Part 21 (PAR)

## PART 21 - ACTUATOR SHAFT DID NOT MEET DIMENSIONAL REQUIREMENTS

**Subject:** Energy Northwest Columbia – Actuator Replacement Shaft Drawing 3489-3  
Exelon Limerick – Actuator Replacement Shaft Drawing W9223896  
Exelon Quad Cities – Actuator Replacement Shaft Drawing W8422061, 62.

**ENGINEERING EVALUATION**  
**10CFR21 File No. 89**

Figure 1  
ENW Photos of Removed and Replacement Actuator Shafts  
and Hinge with Disc

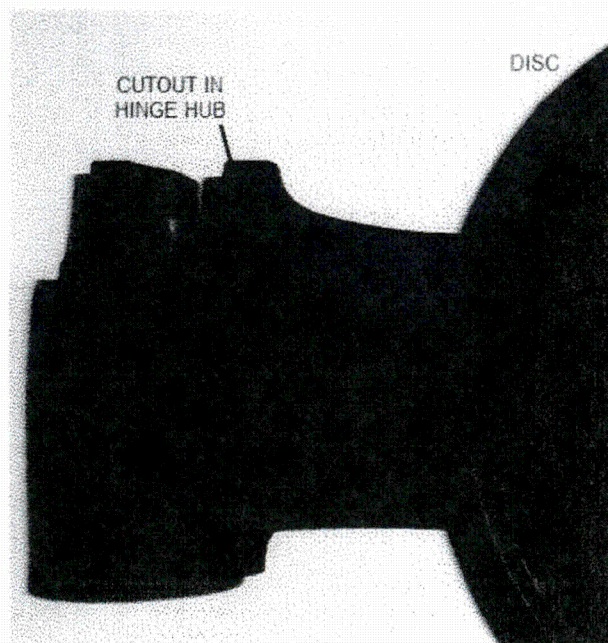
**PROBLEM:** ENW - Columbia reported the replacement actuator shaft was different than the one removed and could not be installed. After consultation with Flowserve it was determined the actuator shaft did not meet the dimensional requirements of the manufacturing drawing. The shaft includes an off-set lug that engages the hinge and allows testing or exercising the valve disc. The shaft diameter opposite the lug must be equal to or less than the basic diameter adjacent to the lug in order to allow free disc swing. See figures 1 photos and 2 drawing.

Figure 2  
 Drawing Showing Installed Actuator Shaft and Evaluated Area

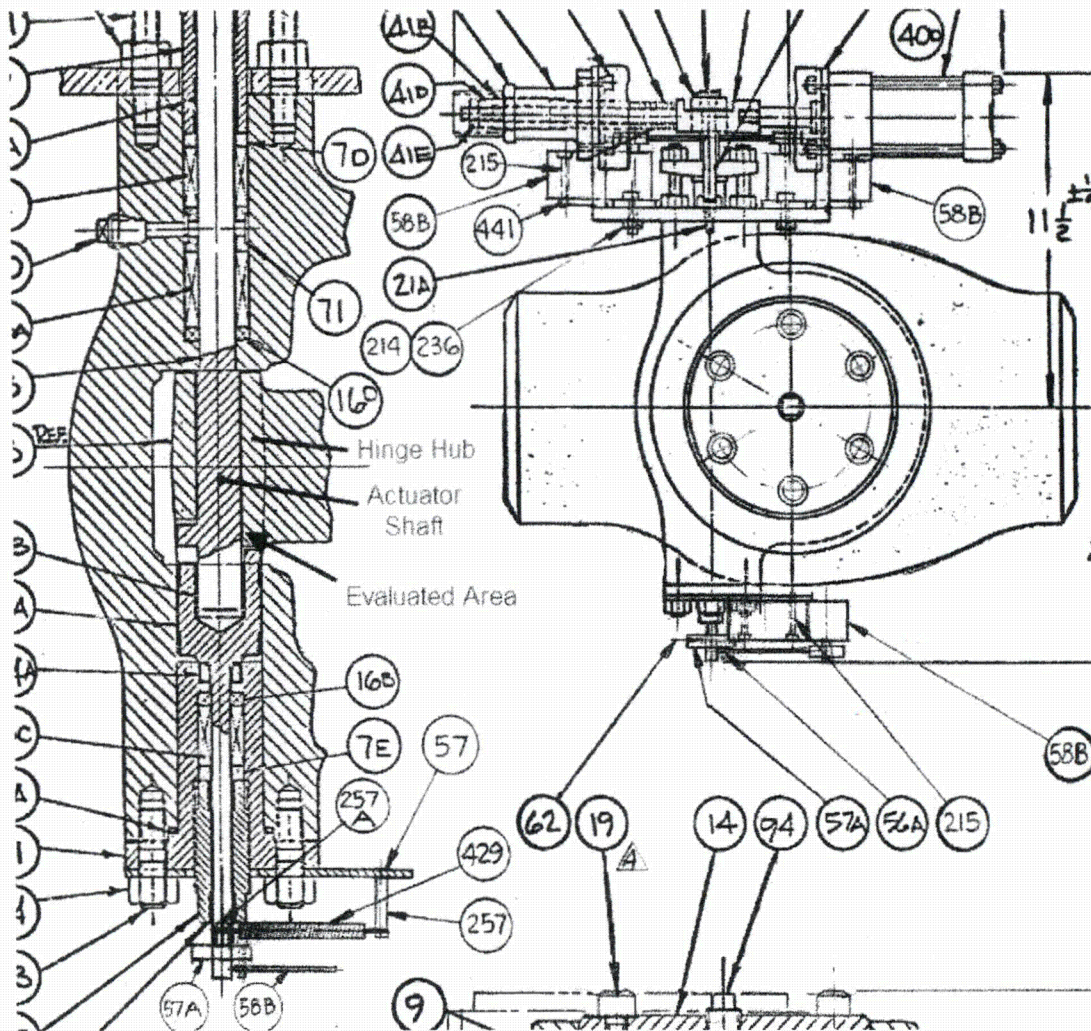
**ROOT CAUSE:** The actuator shaft was machined by a Flowserve subvendor which incorrectly interpreted the machining drawing and produced the shaft with a large, out of tolerance radius around the lug. The drawing was not clear to the subvendor. Flowserve inspection did not discover the discrepancy during subsequent dimensional inspection.

**PROPOSED ACTION:** Flowserve will revise actuator shaft drawing to clearly define the radius/diameter at the lug. Flowserve will notify the customers in table 1 of the attached evaluation of the defect and will request that the actuator shafts be returned to Flowserve for evaluation and/or replacement at no charge.

SECTION A-A

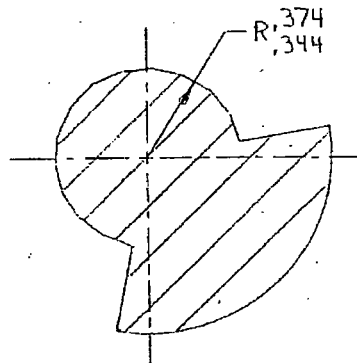
MILL OUT SEGMENTS, IN 20° INCREMENTS  
WITH APPROX. 13 FLATS .130 WIDE X .006 DEEP  
USING 3/8 DIA. CUTTER WITH TOTAL RUNOUT  
TO .842 MAX. AS SHOWN. SURFACE FLUSH  
OR UNDER ADJACENT .748 DIA.
